**Part 3:
Initialization and anticollision**

**AMENDMENT 1: Electromagnetic
disturbance handling and single-size unique
identifier**

Amendment 1 to ISO/IEC 14443-3:2011 was prepared by Joint Technical Committee ISO/IEC JTC 1, *Information technology*, Subcommittee SC 17, *Cards and personal identification*.

AMENDMENT 1: Electromagnetic disturbance handling and single-size unique identifier

Figure 1 — Frame delay time PCD to PICC

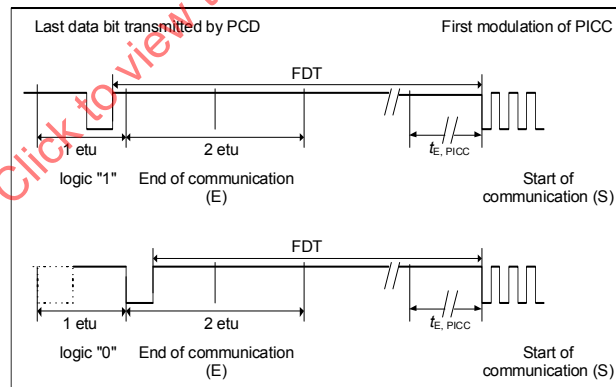
Page 7, 6.2.1.1

Replace Figure 1 with the following:

NOTE $t_{E,PICC}$ is specified in Clause 8.

Figure 17 — Timing before the PICC SOF

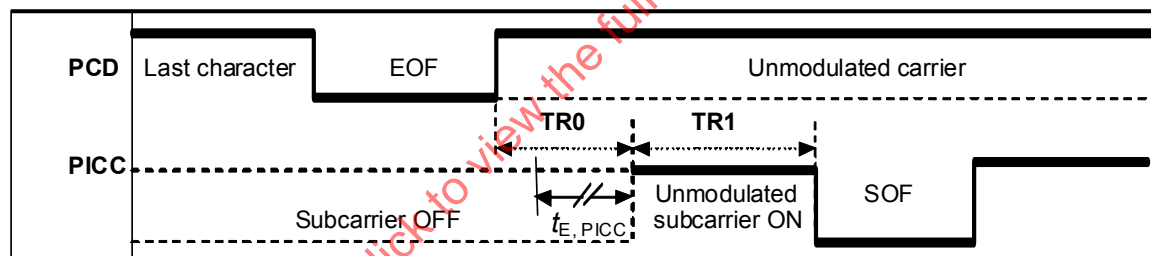
Replace Figure 17 with the following:

NOTE $t_{E, PICC}$ is specified in Clause 8.

Figure 33 — Low EMD time

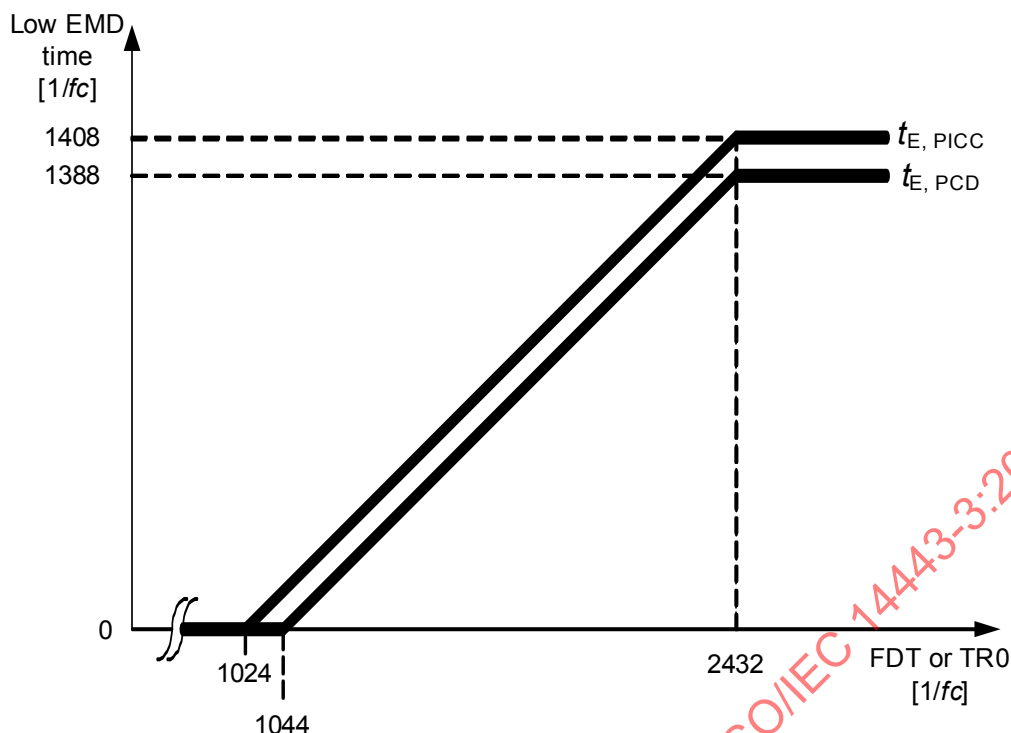
Insert the following new clause after Figure 32:

The low EMD time $t_{E,PICC}$ is the time period before the start of PICC data transmission, when the PICC shall not produce an EMD level higher than the EMD limit as defined in ISO/IEC 14443-2/Amd.1.

This low EMD time $t_{E,PICC}$ has a value of $F - 1024/f_c$ with a maximum value of $1408/f_c$ where F equals FDT for Type A and TR0 for Type B. The value is $0/f_c$ for $TR0 \leq 1024/f_c$.

The low EMD time $t_{E,PCD}$ is the time period to allow the PCD to recover from electromagnetic disturbances.

The PCD shall be ready to process a PICC frame no later than $t_{E,PCD}$ after the last time the EMD level was above the EMD limit as defined in ISO/IEC 14443-2/Amd.1.

This low EMD time $t_{E,PCD}$ has a value of $F - 1044/f_c$ with a maximum value of $1388/f_c$ where F equals FDT for Type A and TR0 for Type B. The value is $0/f_c$ for $TR0 \leq 1044/f_c$.

The low EMD time for PCD and PICC are illustrated in Figure 33.
